North Dakota Department of Transportation

ADDENDUM 1 – JOB 2

TO: All prospective bidders on projects SOIA-7-085(096)192, Job No. 2 scheduled for the May 22, 2014 bid opening.

SRF No. 7594

Revised 5/12/2014	STATE	PROJECT NO.	SECTION NO.	SHEET NO.
	ND	SOIA-7-085(096)192	75	3

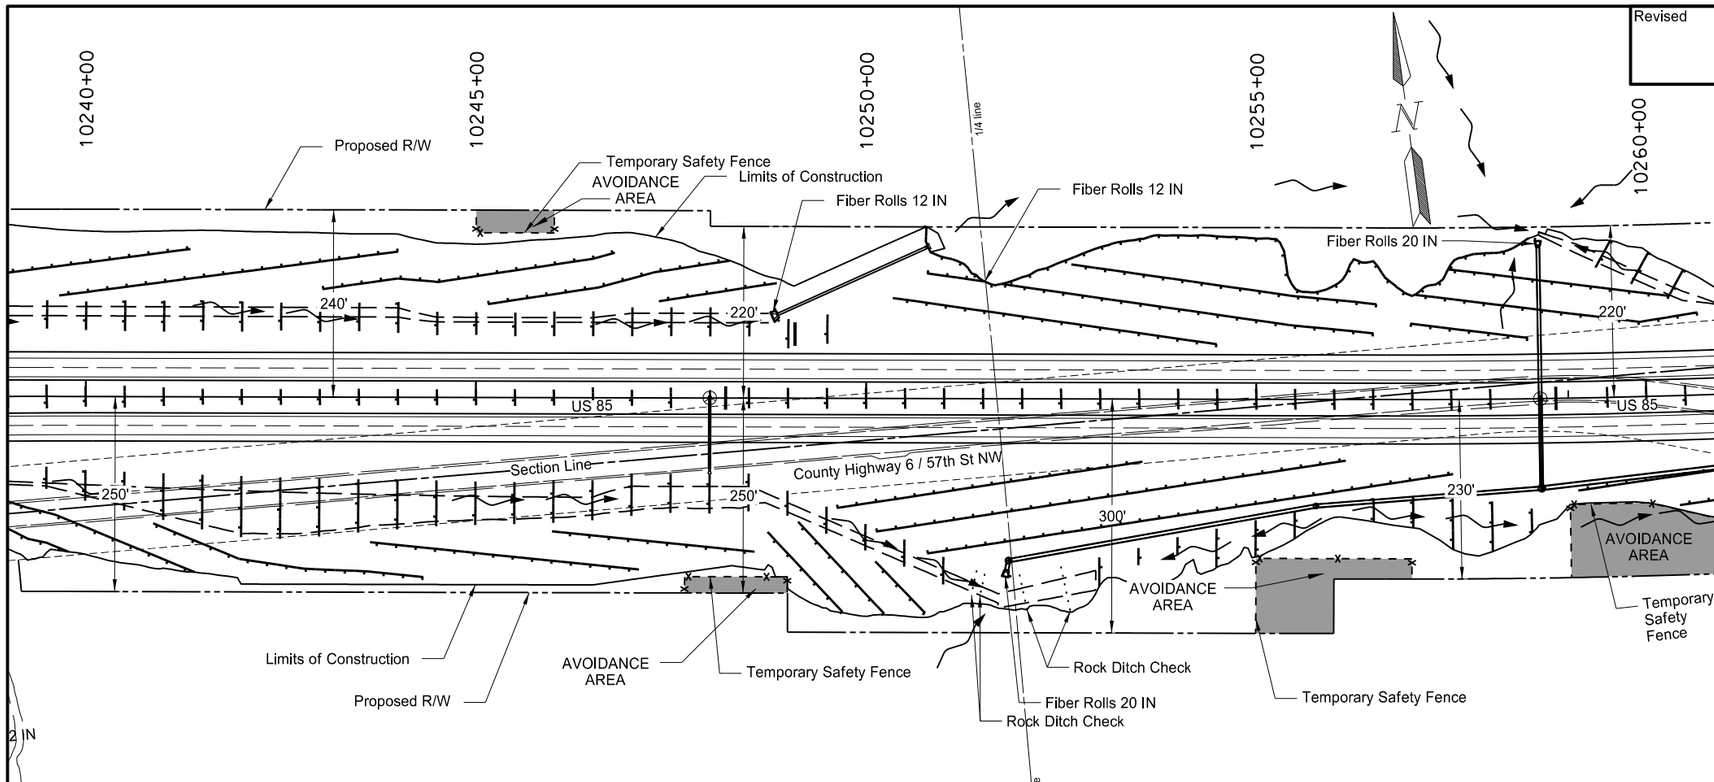
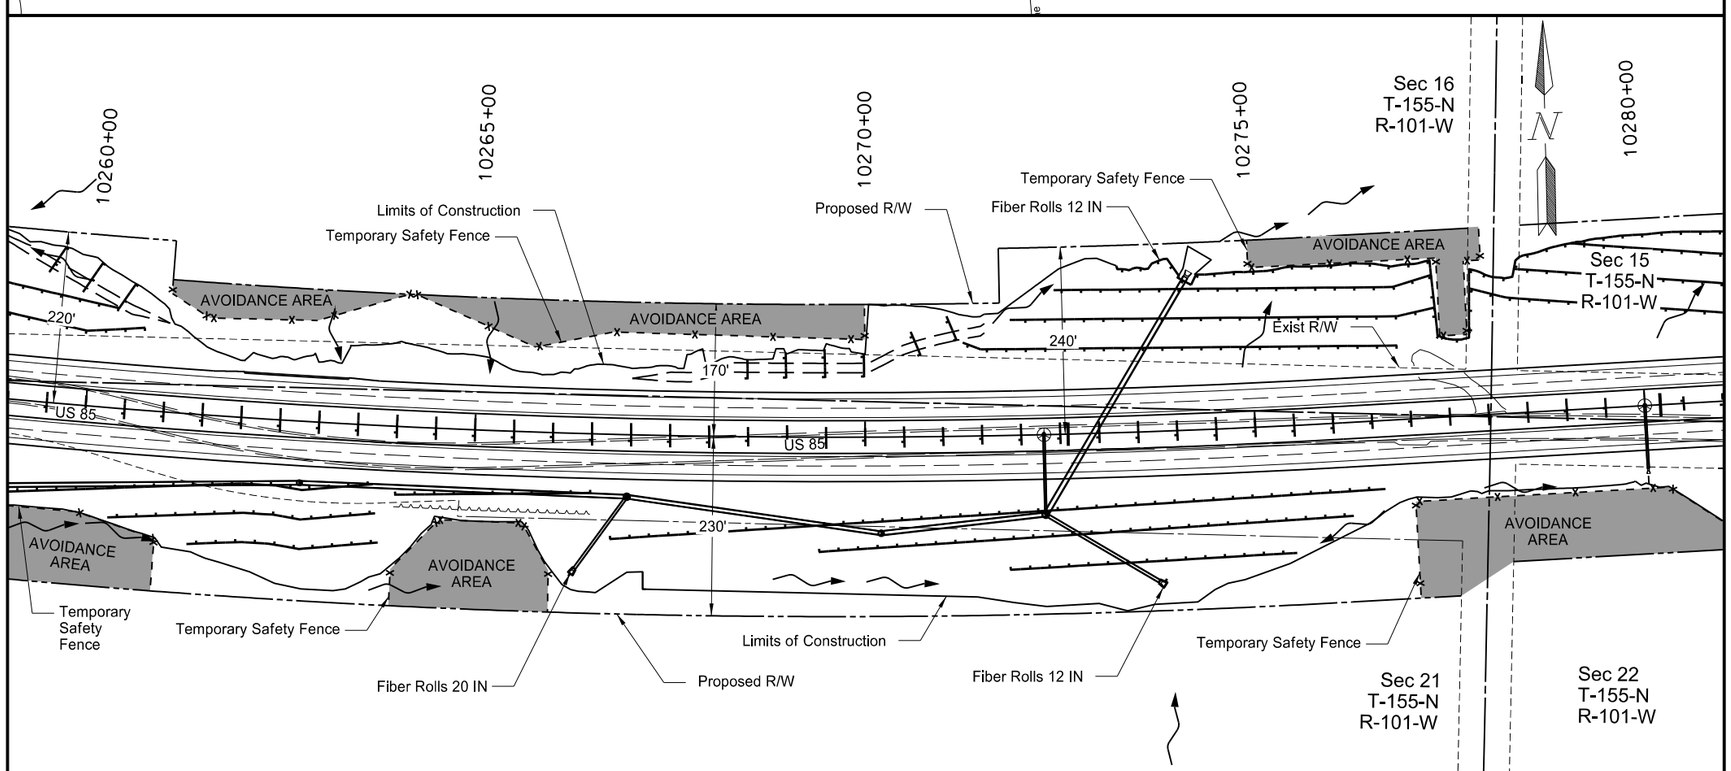
Sheet 75-3:
Revised the temporary erosion control to accommodate the changes at the retaining wall

Revised 5/12/2014	STATE	PROJECT NO.	SECTION NO.	SHEET NO.
	ND	SOIA-7-085(096)192	75	13

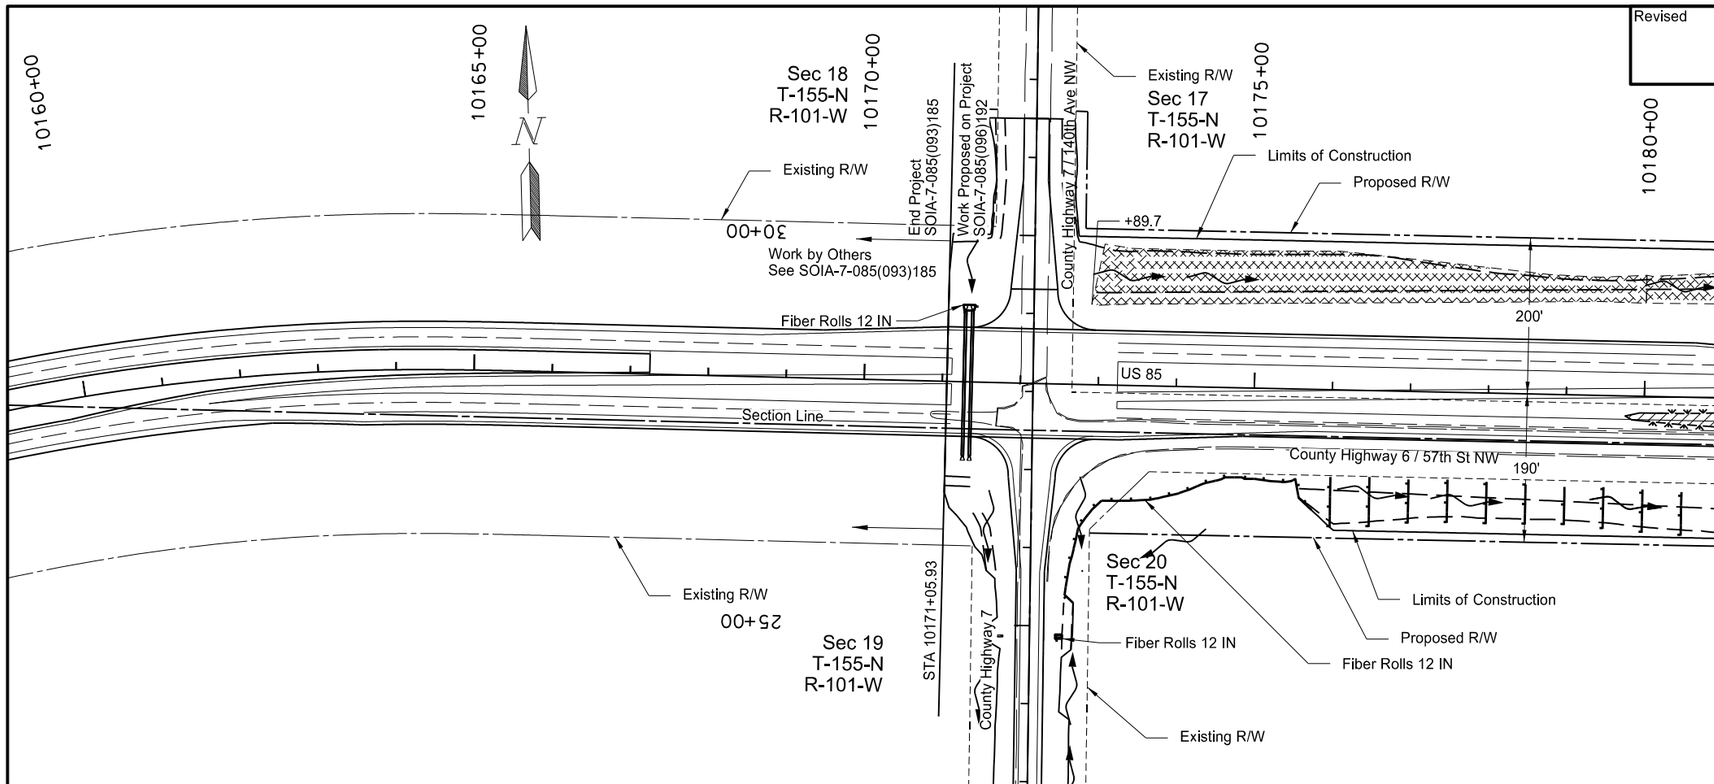
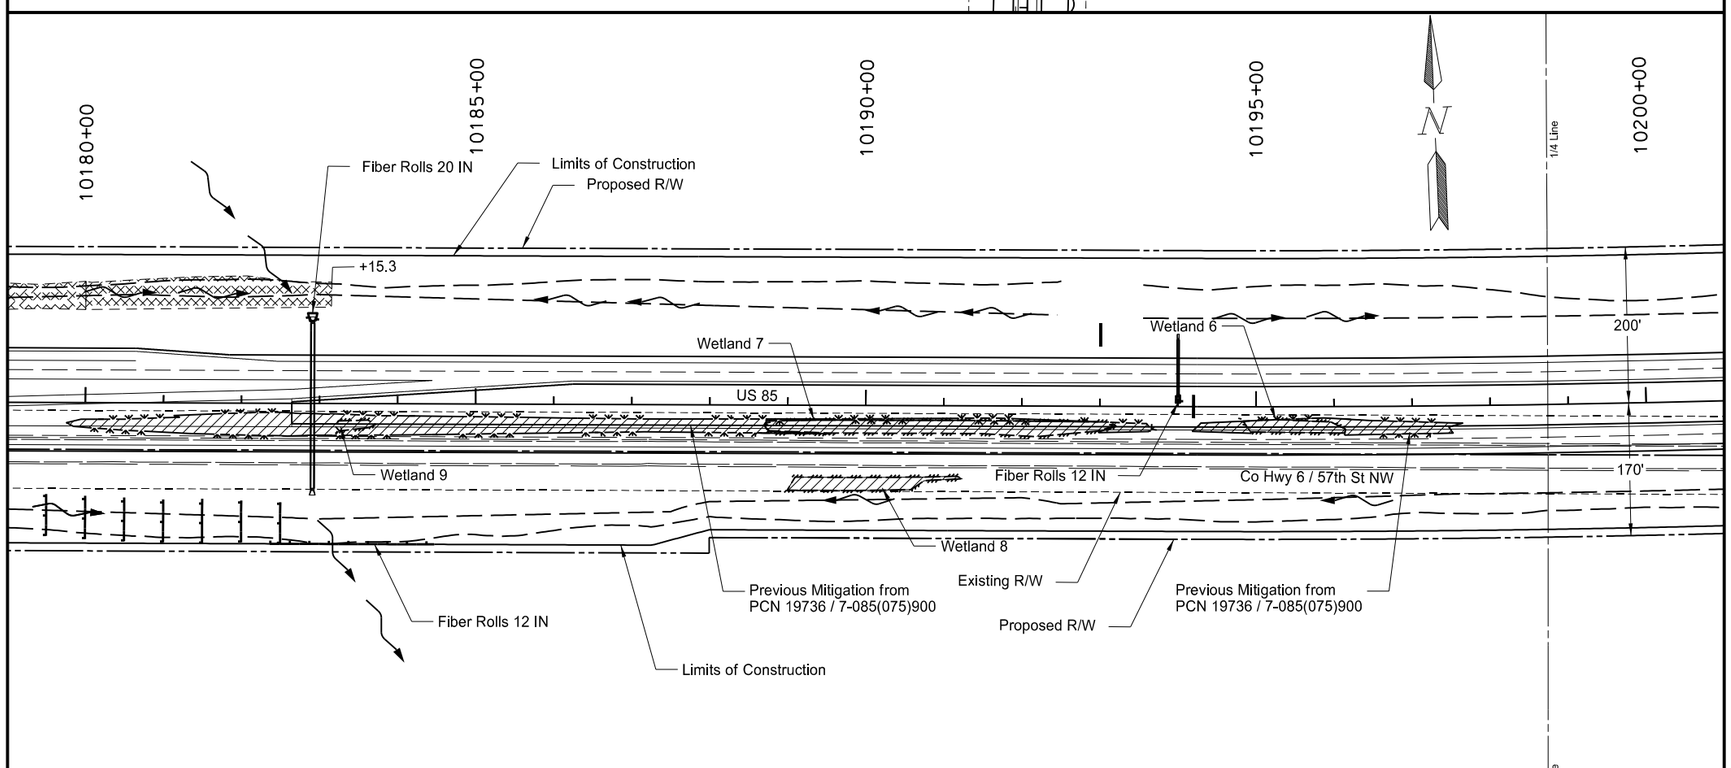
Sheet 75-13:
The center pipe size at station 10182+90 has changed

Revised 5/12/2014	STATE	PROJECT NO.	SECTION NO.	SHEET NO.
	ND	SOIA-7-085(096)192	75	15

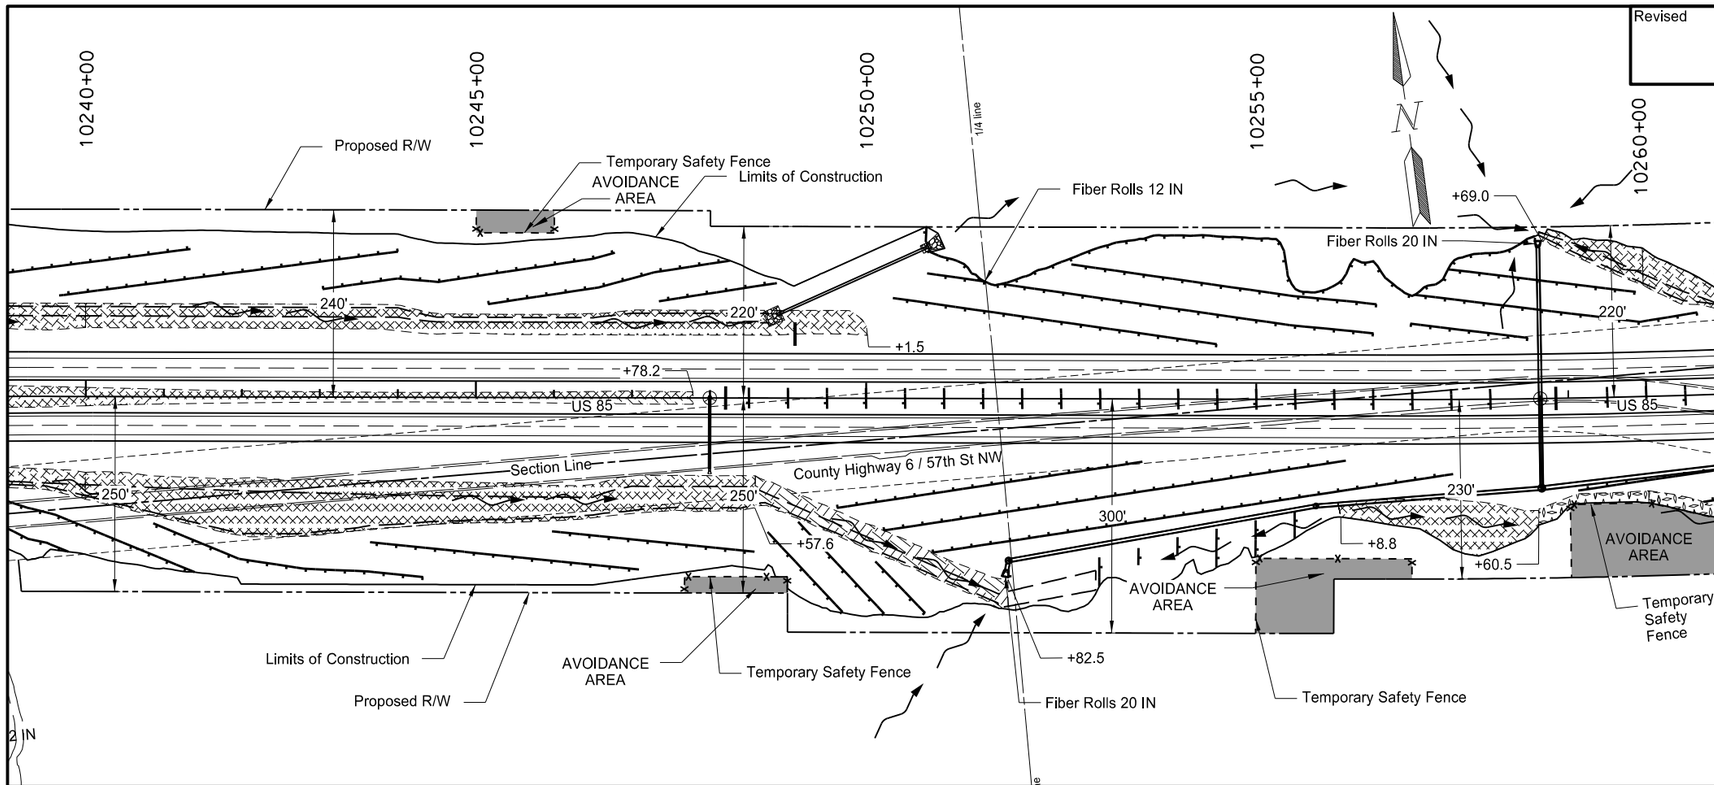
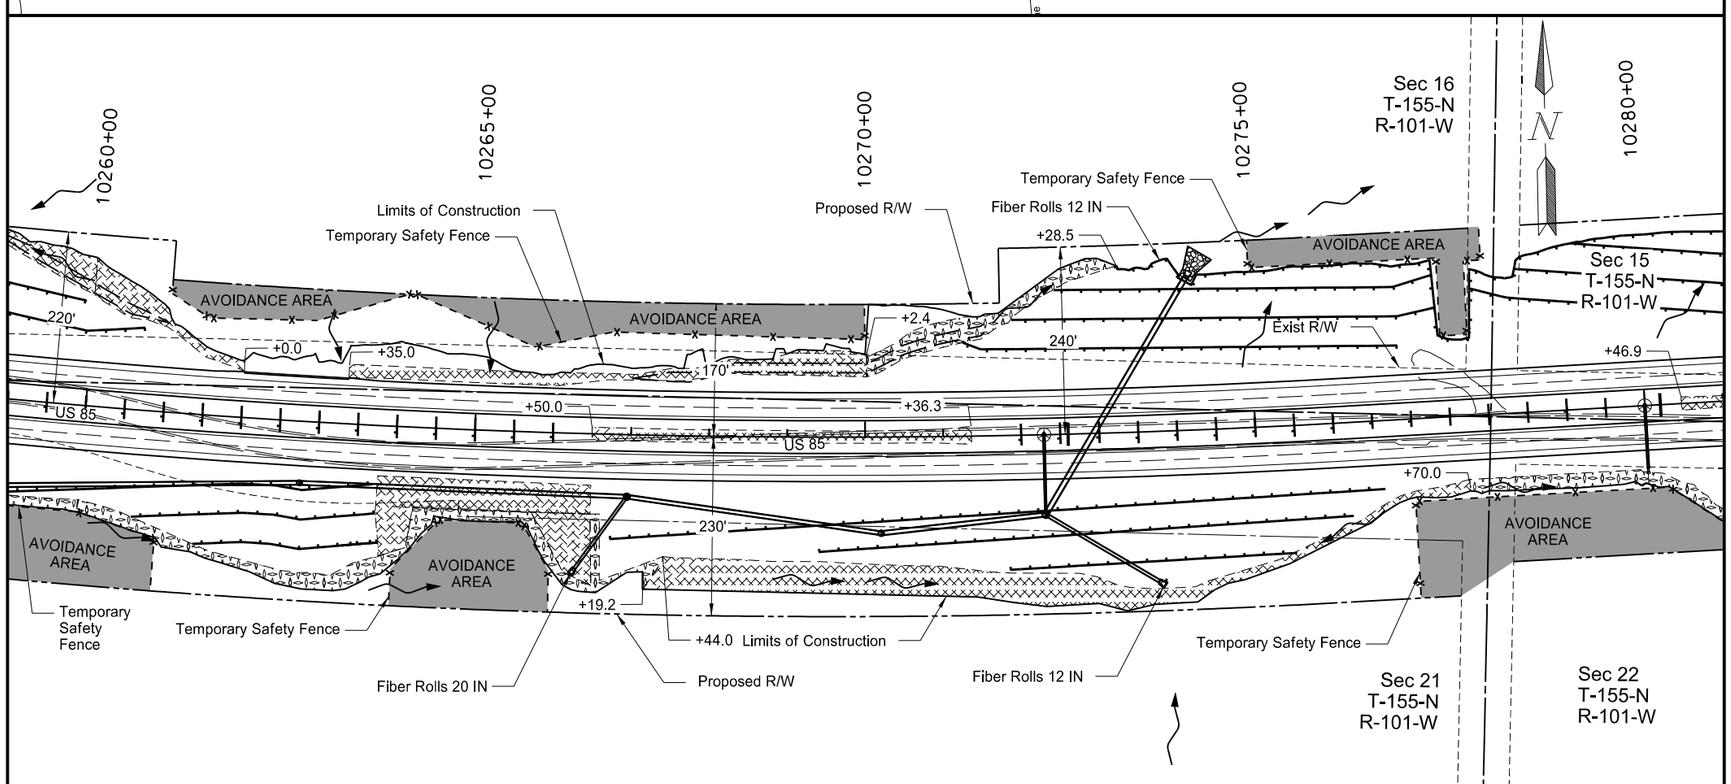
Sheet 75-15:
Revised the permanent erosion control to accommodate the changes at the retaining wall

Revised	5/14/14	STATE	PROJECT NO.	SECTION NO.	SHEET NO.
		ND	SOIA-7-085(096)192	80	3

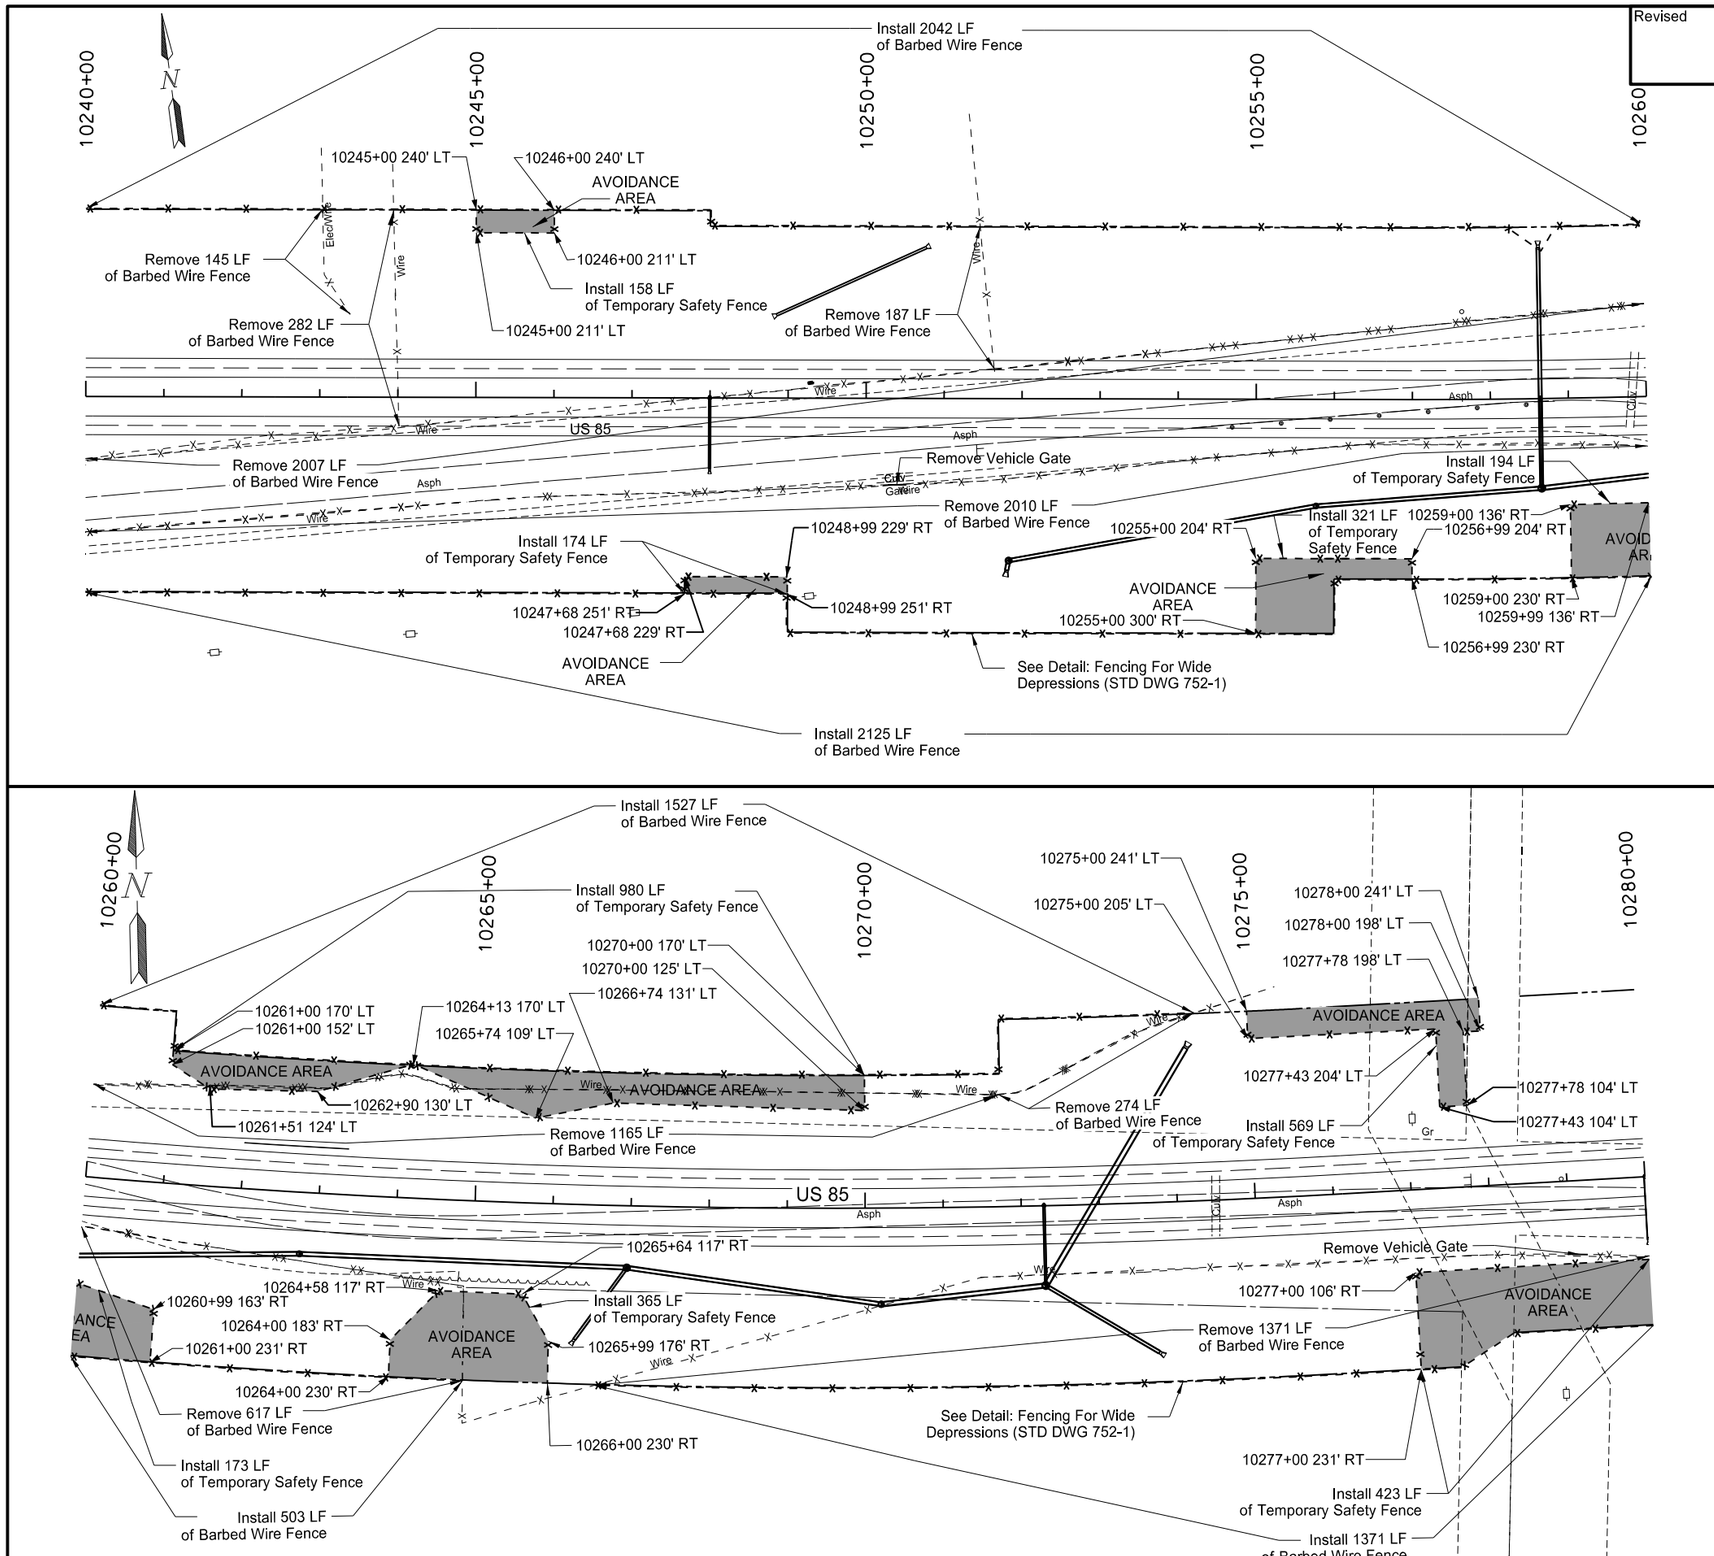
Sheet 80-3:
Revised due to change in retaining wall.
